CIR Response

CIR #19

Carleton Place Arena
Renovation and Addition

SITE INSTRUCTION NO. ME-07 MECHANICAL AND ELECTRICAL

2 SECOND FLOOR PLAN
FA1 SCALE: 3/32" = 1'-0"

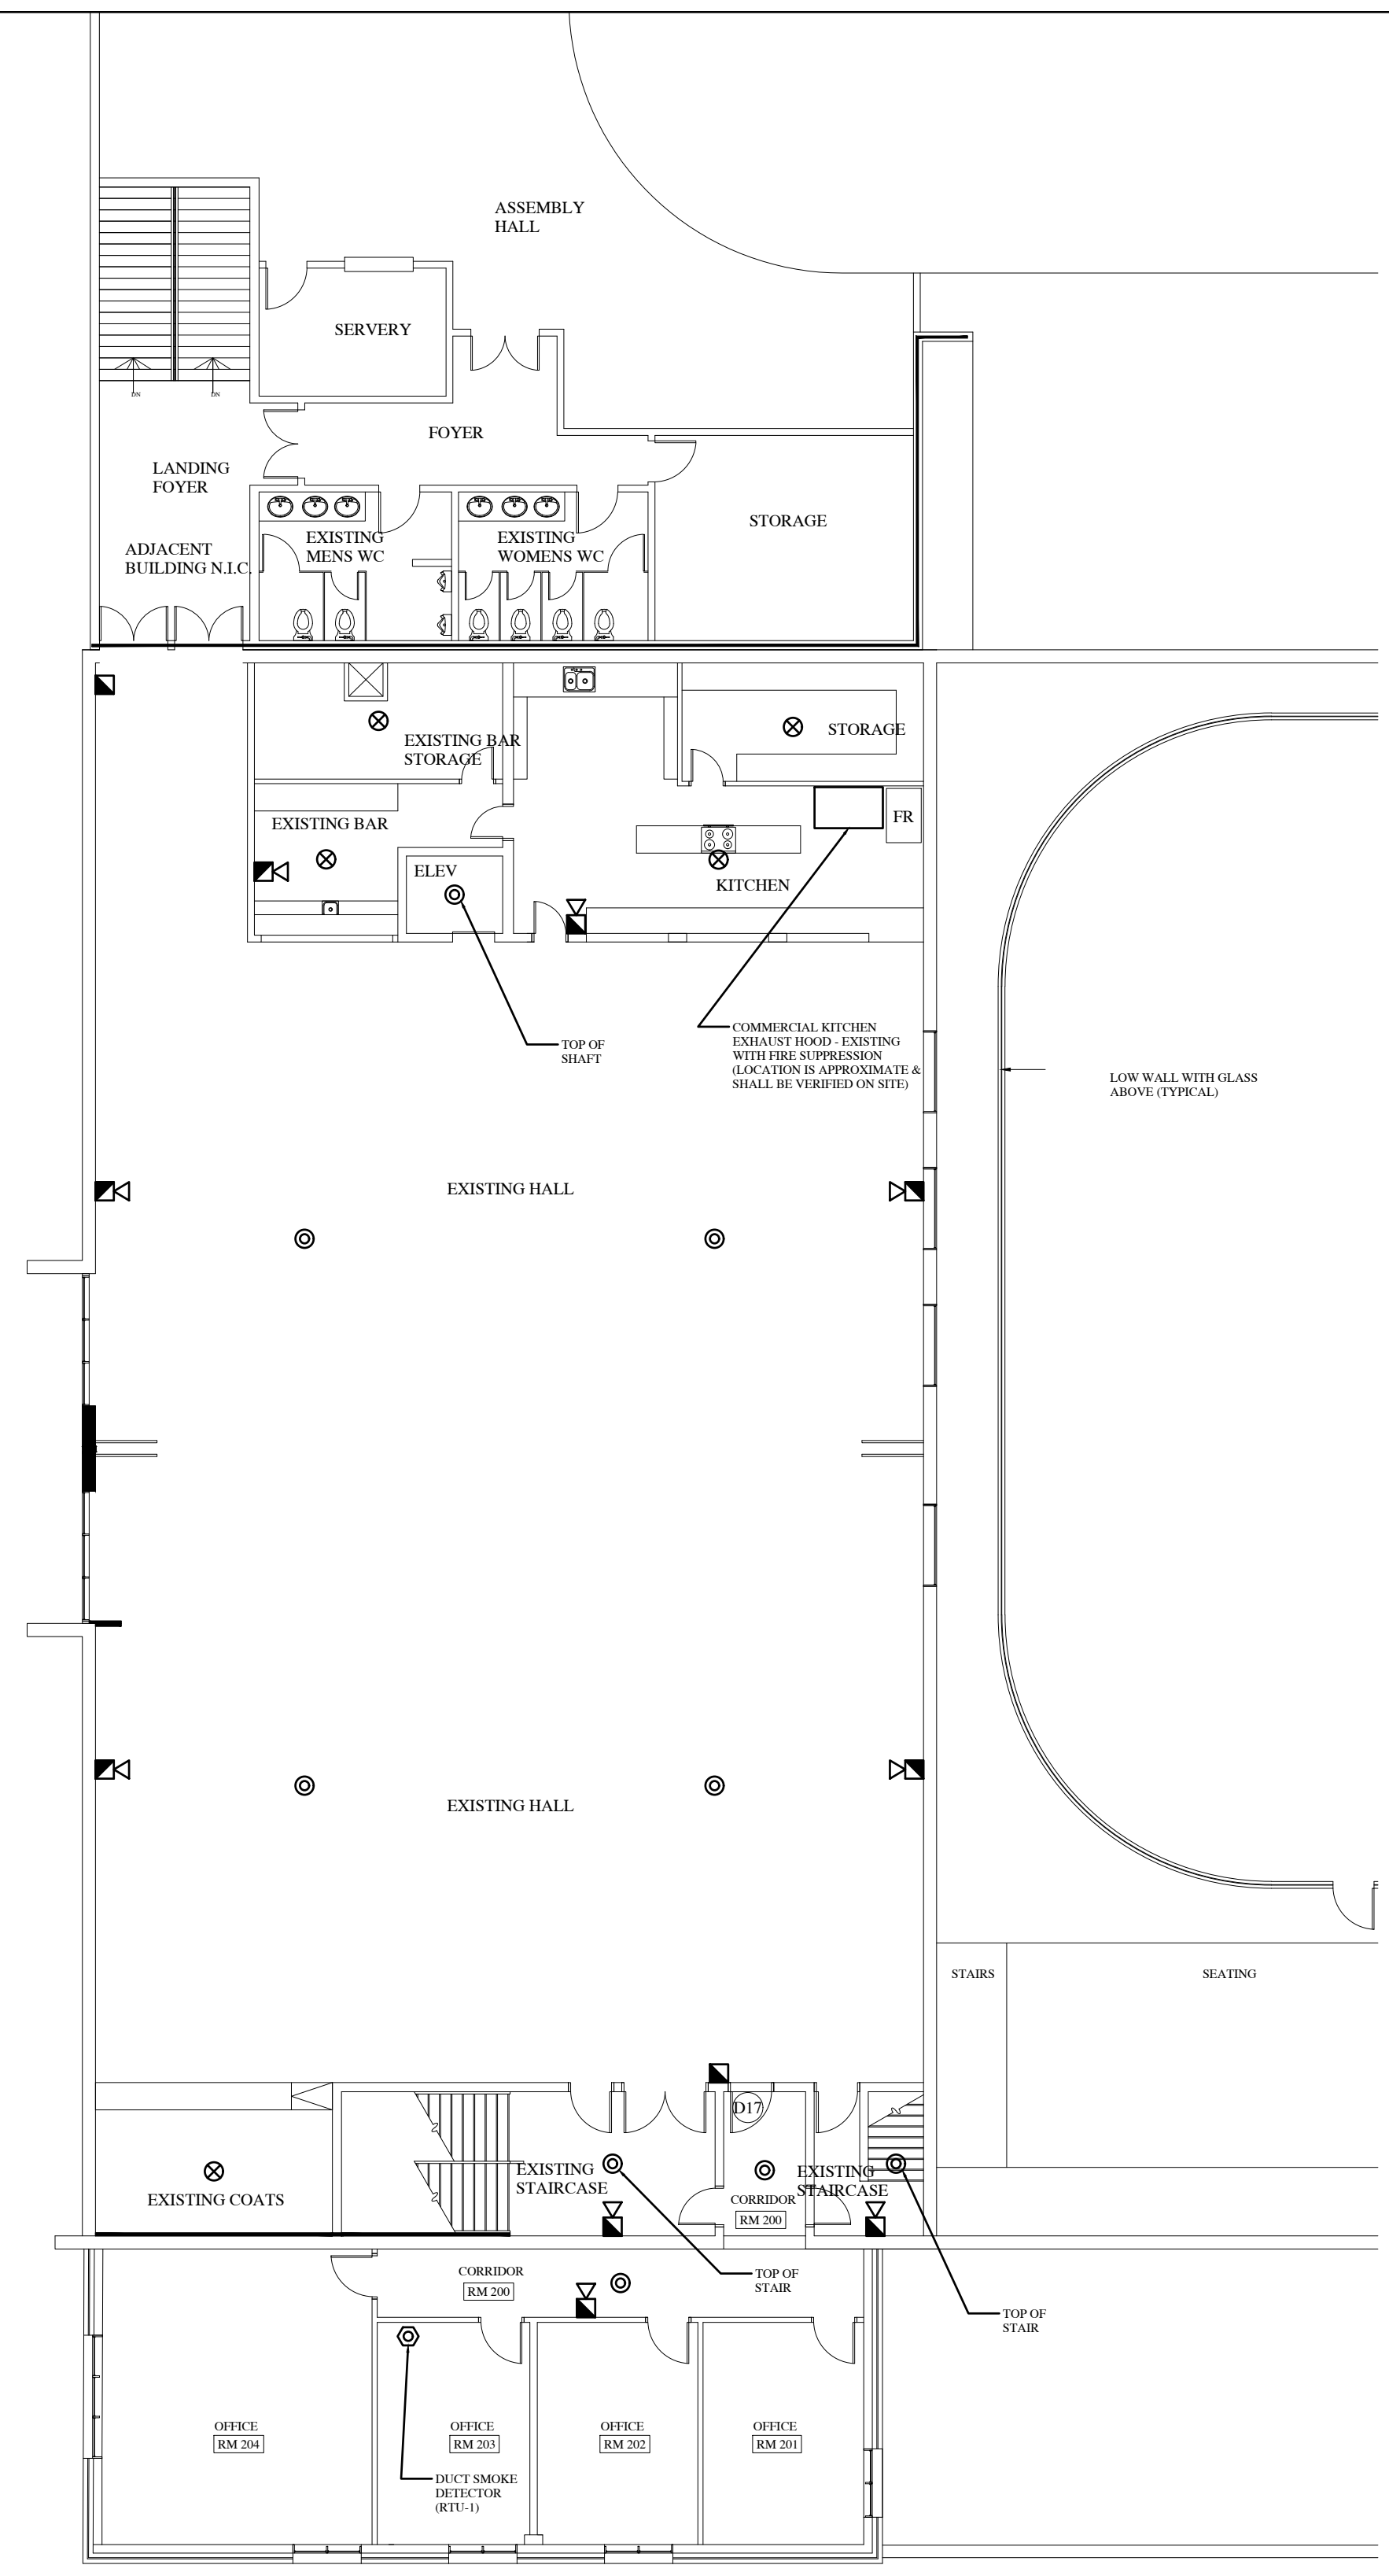
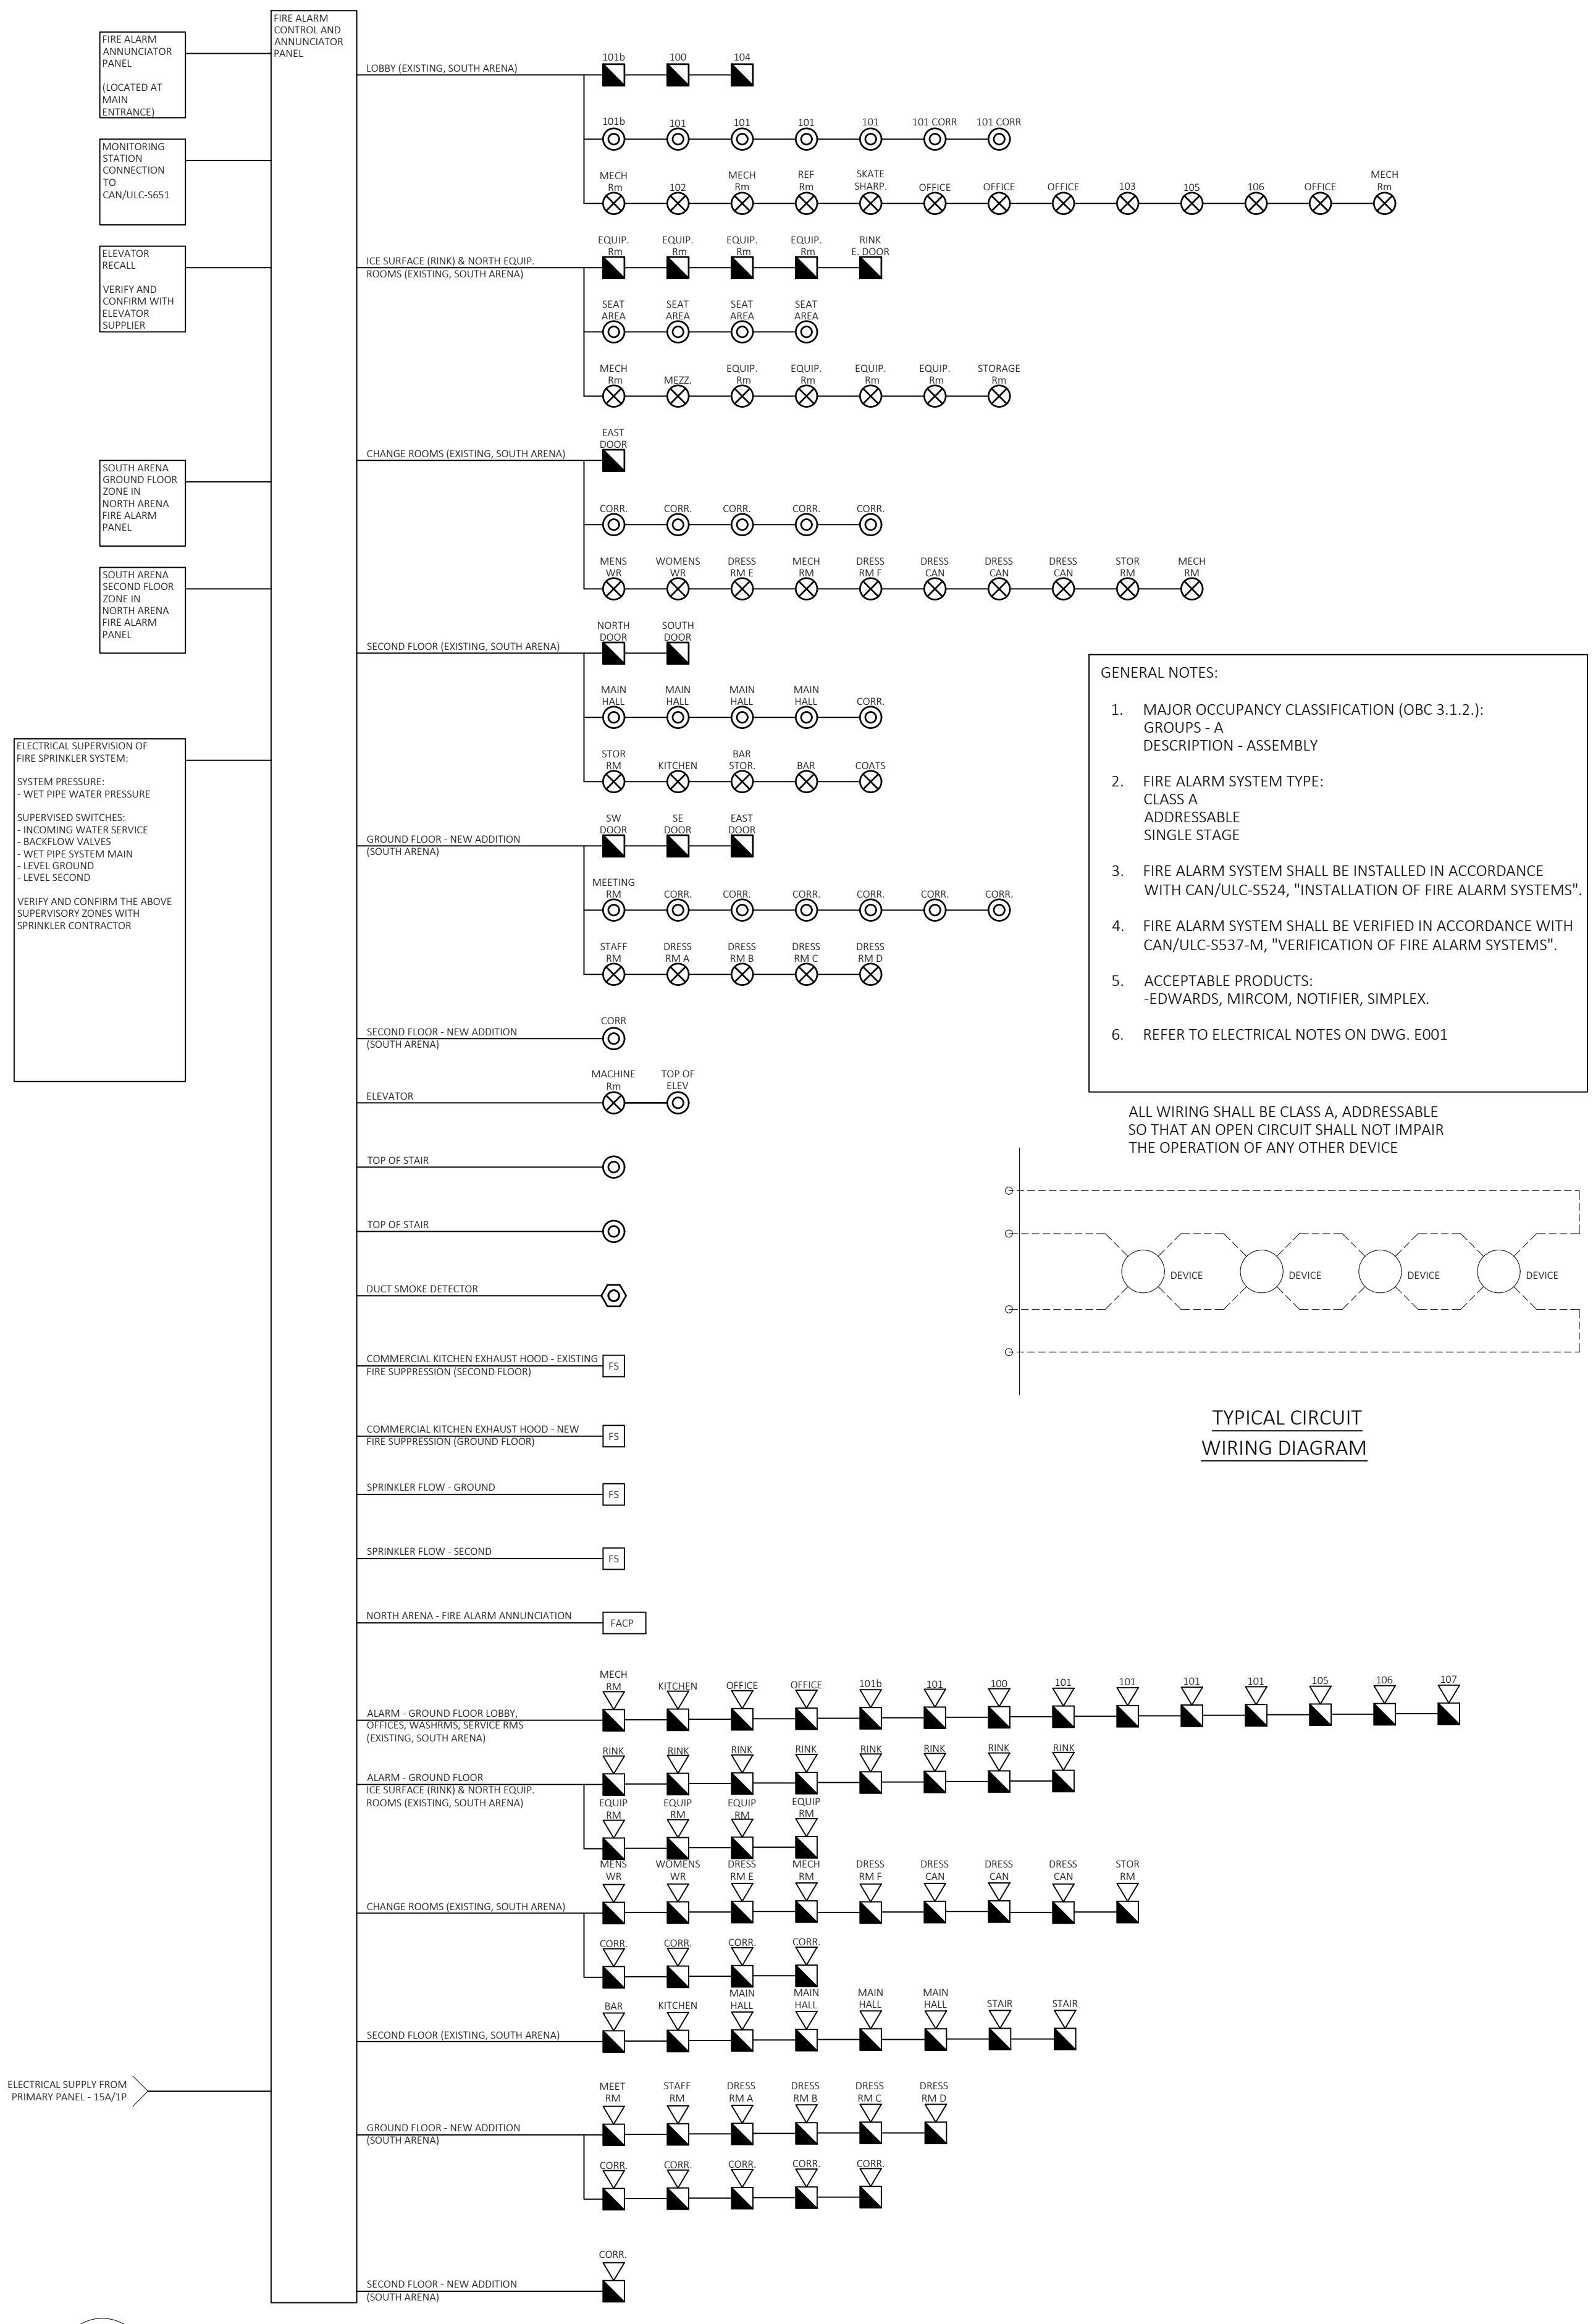
1. To maximize the decibels and light output, our electrical contractor in correlation with their Fire Alarm sub-trade are proposing to install several horn and strobes on the ceilings instead of on walls, the areas where we propose this devices ceiling mounted are as follows:
 - Dressing rooms E, F and Canadians
 - Existing washrooms under the stands
 - Mechanical rooms under the stands
 - Lobby area
 - Washrooms in lobby area
 - Offices in lobby area
 - Office room 107
 - Existing hall on 2nd floor
 - Corridor rm 200

E7.2 DRAWINGS FA1 & FA2 – REVISION 1:

.1 The following items have been deleted from the list in the M&E Addendum:
